Product Change Notification

PCN #: 5C-2018

DATE: 10th May 2018

Laird Part Number	Description
BL652-SA-01	Bluetooth v5 Module + NFC (Integrated Antenna)
BL652-SC-01	Bluetooth v5 Module + NFC (External Antenna)
BL652-SA-01-T/R	Bluetooth v5 Module + NFC (Integrated Antenna) – Tape & Reel
BL652-SC-01-T/R	Bluetooth v5 Module + NFC (External Antenna) – Tape & Reel
DVK-BL652-SA-01	Development Kit - Bluetooth v5 Module + NFC (Integrated Antenna)
DVK-BL652-SC-01	Development Kit - Bluetooth v5 Module + NFC (External Antenna)

Figure 1: Module label

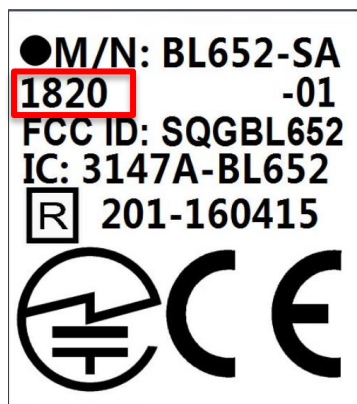
The change can be identified by reviewing the **Build Code** number that is present on the individual module, reel label and carton label. The images below identify where this **Build Code** is located on each of those labels.

A Build Code that starts with **1820**, and all subsequent incremental numbers, indicates that the nRF5283-QFAA-E00 silicon is utilised.
